# eel pie boatyard

Re: London Borough of Richmond Upon Thames (Twickenham Riverside) Compulsory Purchase Order 2021, Compulsory Purchase of Land and New Rights in Twickenham Riverside

#### 08/05/23

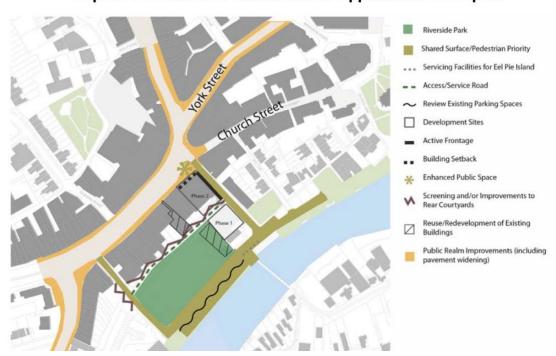
- To clarify this is to enable 3 parked up servicing bays where subcontractor's and trades people can park close to the bridge and because of the loss of pay and display parking. This is not an increase/improvement in loading bays. They are now closer to river. (Floodzone)
- The high tide floods the proposed service area at the bottom of Water Lane, on high spring times and when the river is in flood due to heavy rainfall or tidal surge.
- Vehicle turning is not possible at high tides, egress must be via the Embankment and Wharf Lane.

In response 11.37......Scheme and there would be a dedicated servicing area for the Island next to the bridge which would include 6 loading bays. This would represent an improvement to the current situation

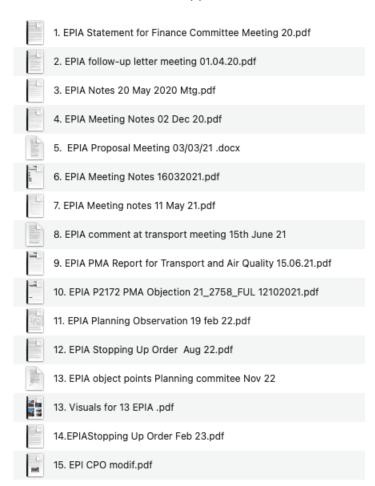
- Adherence to the plan in the TAAP Map 7.14 with designated uses.
- Outline planning was given for a scheme that kept the access way and allowed the local community to keep their infrastructure and go about their daily lives.

- It was never followed through because of a change in administration.
- Diamond Jubilee Garden retained, and the derelict buildings be redeveloped.
- The high street has lost nearly all the banks, there are many empty shops.
- Use empty shops for community projects or change of use to affordable living spaces.
